Administrative Action Preliminary Subdivision City of Raleigh Development Plans Review Center One Exchange Plaza Raleigh, NC 27602 (919) 996-2626 www.raleighnc.gov

Case File / Name: S-9-13 / Dorothea Commons

Nature of Case: The subdivision of a 1.44 acre property zoned Residential-20 with Planned Development Conditional Use Overlay District into 19 single-family residential lots and one open space lot. The Master Plan associated with this site allows for 14 dwelling units per acre which would allow for 20 detached single family dwellings.

SUBJECT:	S-9-13 Dorothea Commons
CROSS- REFERENCE:	MP-1-11 Dorothea Commons (Z-13-11)
LOCATION:	This site is located on the south side of Dorothea Drive between its intersections with South Saunders Street and Florence Street, inside the City Limits.
REQUEST:	This request is to approve the subdivision of a 1.44 acre tract into 20 lots (19 single-family, 1 open-space), zoned Residential-20 and Planned Development Conditional Use Overlay District.
OFFICIAL ACTION:	Approval with conditions
OFFICIAL ACTION: CONDITIONS OF APPROVAL:	Approval with conditions Prior to issuance of a grading permit for the site:
CONDITIONS OF

S-9-13 / Dorothea Commons – Preliminary Subdivision Plan

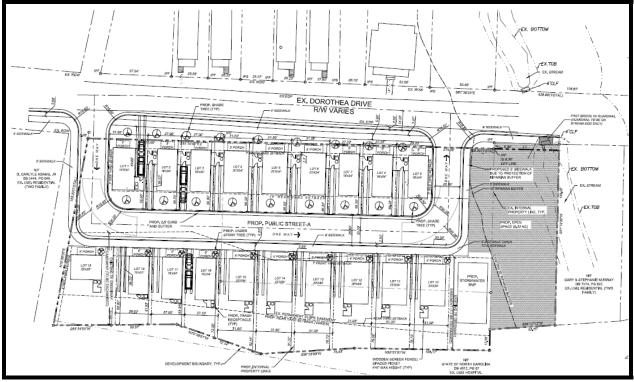
- (3) The level spreader-vegetated filter strip system must be designed as outline in the NC BMP Design Manual for pollutant removal credit. Appropriate details must be shown on the plans;
- (4) That a nitrogen offset payment must be made to a qualifying mitigation bank;

- (5) That all conditions above are met;
- (6) That approval must be obtained from the Division of Water Quality for direct discharge into the stream through the proposed catch basin on top of the existing culvert;

- (7) That approval must be obtained from the Division of Water Quality with regard to impacts to the Neuse Riparian Buffer;
- (8) That approval must be obtained from the Division of Water Quality for direct discharge into the stream through the proposed catch basin on top of the existing culvert;
- (9) That in accordance with the approved Master Plan conditions, the location of fire hydrants 10-2057(f) (2) I, 7.Fire Hydrants are located at every "named" street intersection per City of Raleigh Public Utilities Handbook 2005 Ed. Water Design Standards 1.c.3 (Sheet C 2.2). All parts of all buildings or any structure shall be within 300 feet of a fire hydrant.
- (10) That the level spreader-vegetated filter strip system must be designed as outline in the NC BMP Design Manual for pollutant removal credit. Appropriate details must be shown on the plans;

- (15) Private drainage easement around the stormwater device must be shown on the plat for maintenance purposes. This easement must be extended to a public right of way;
